Eldridge Street Synagogue

Interior Restoration & Faux Finishes

Sheet Title
Main Floor Plan

Drawing No.
A-2

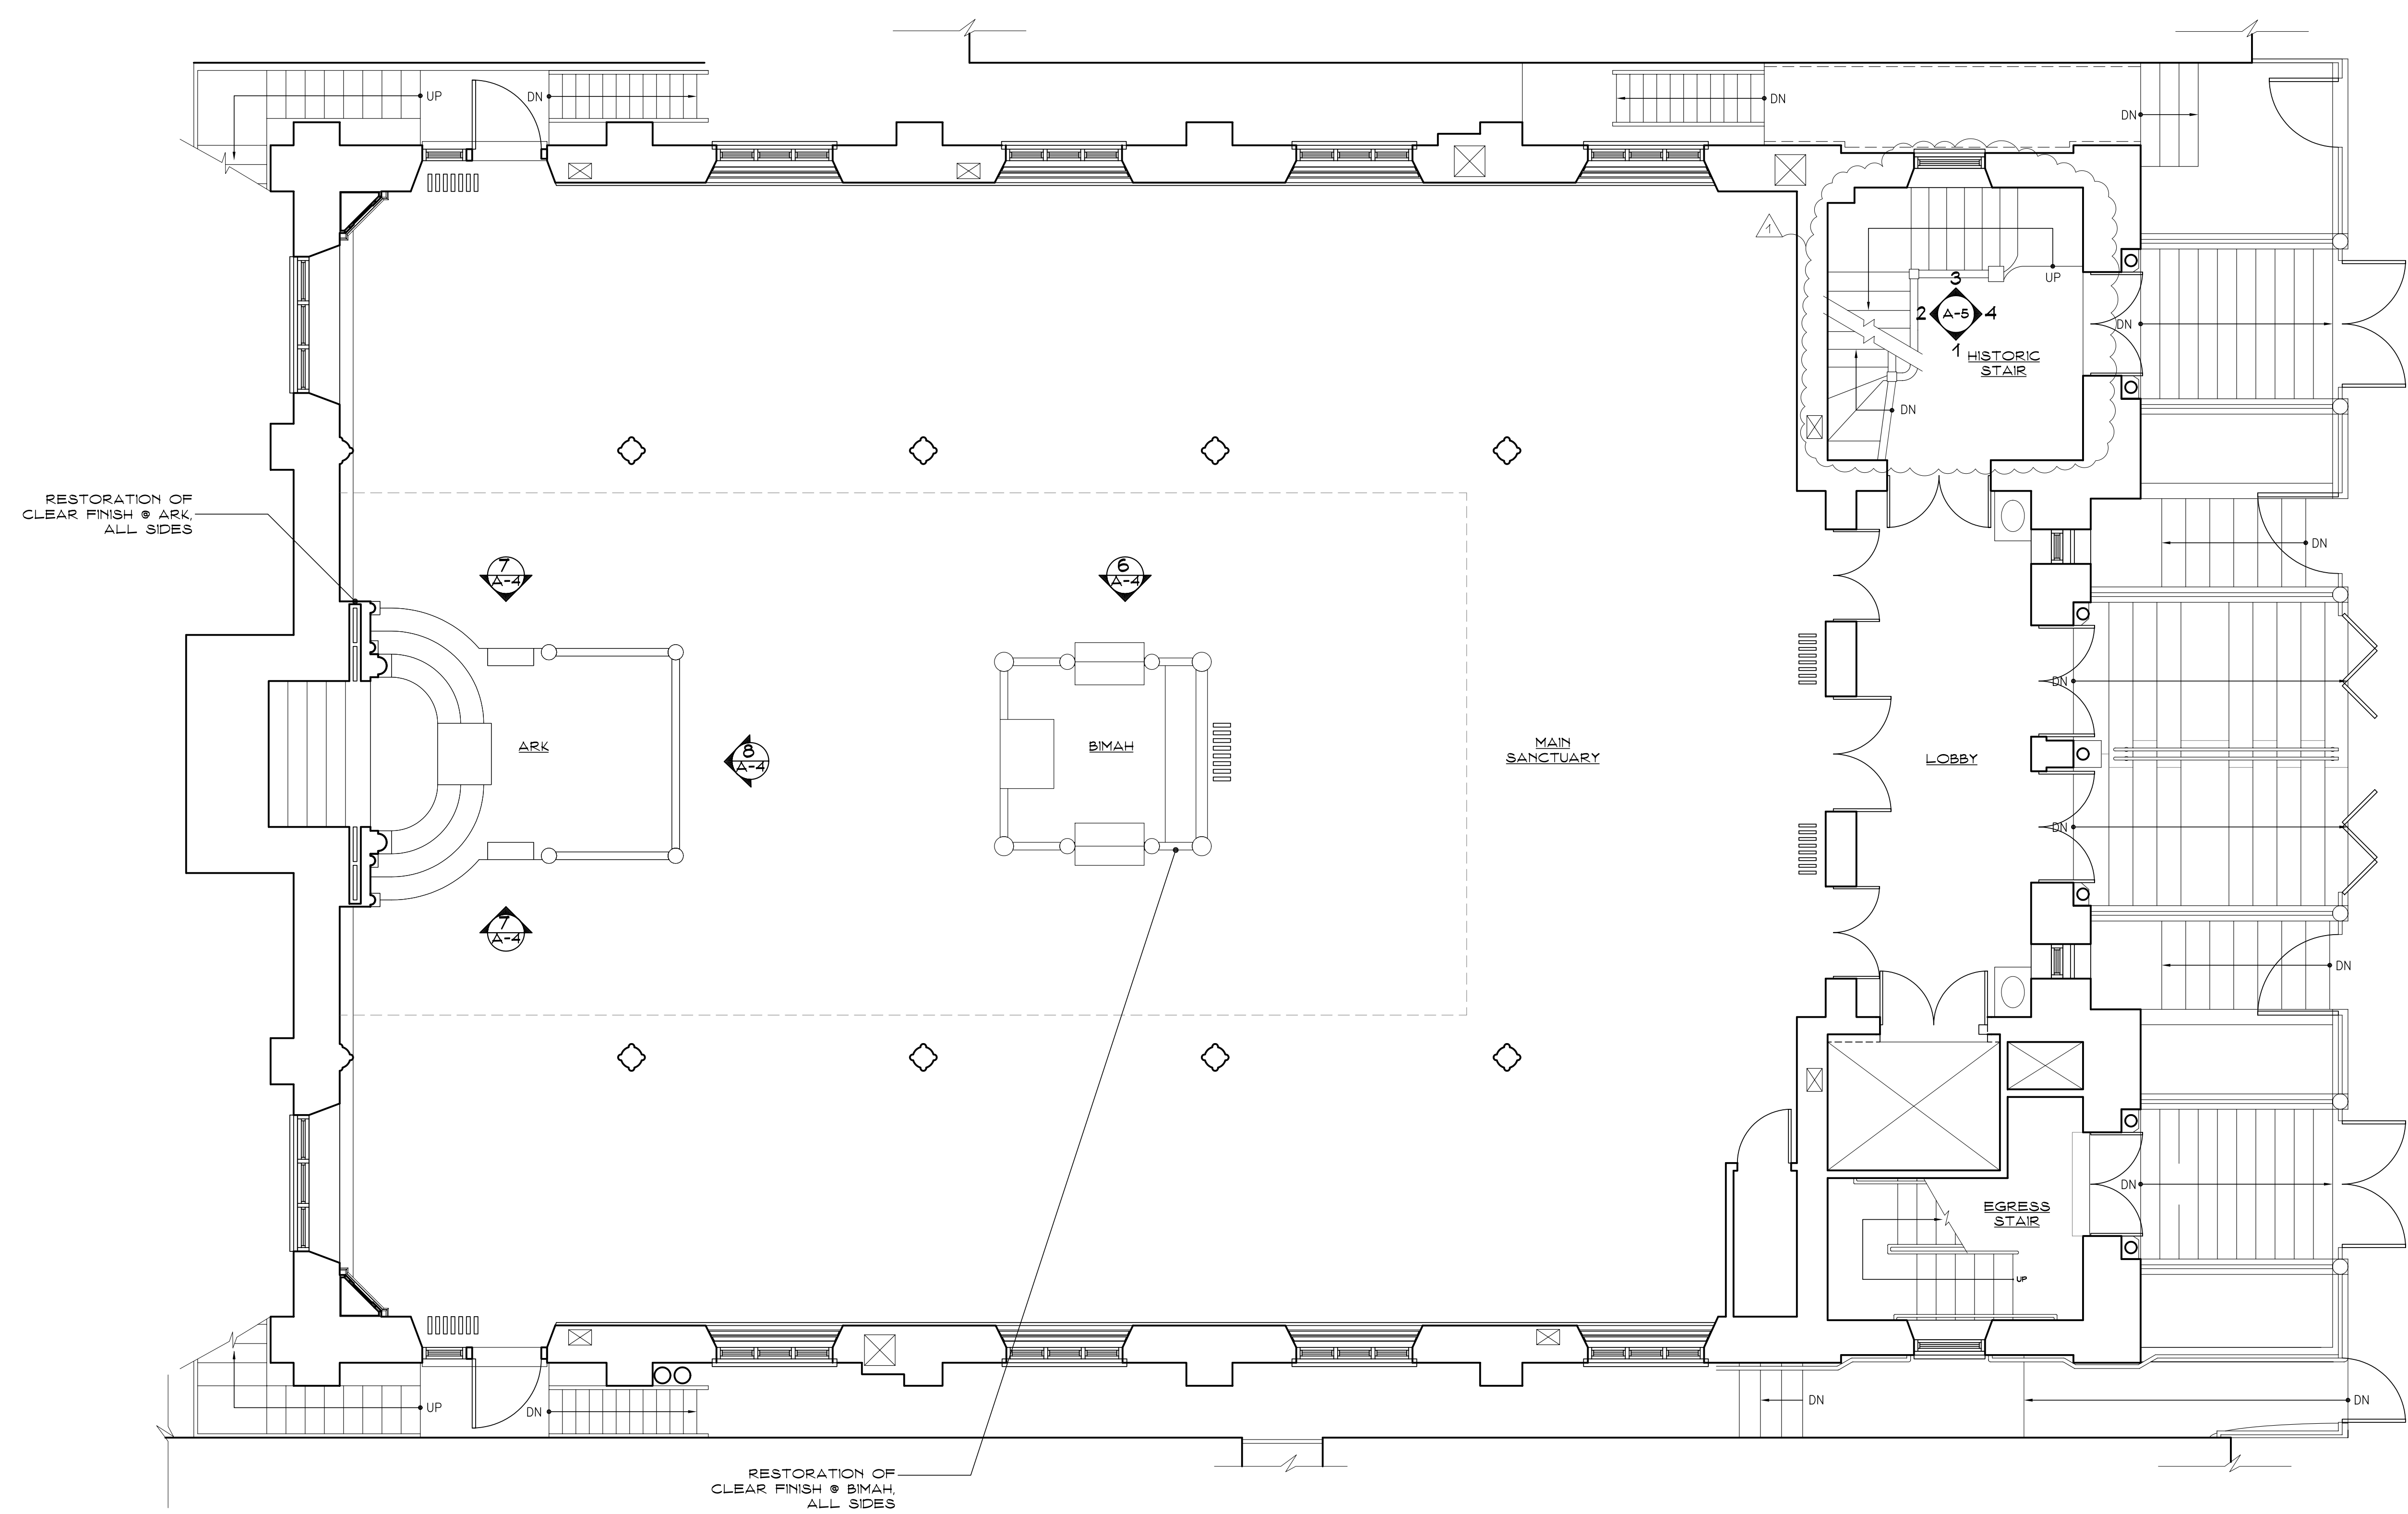
CLEAR FINISH TO INCLUDE ENTIRE WOOD ELEMENT
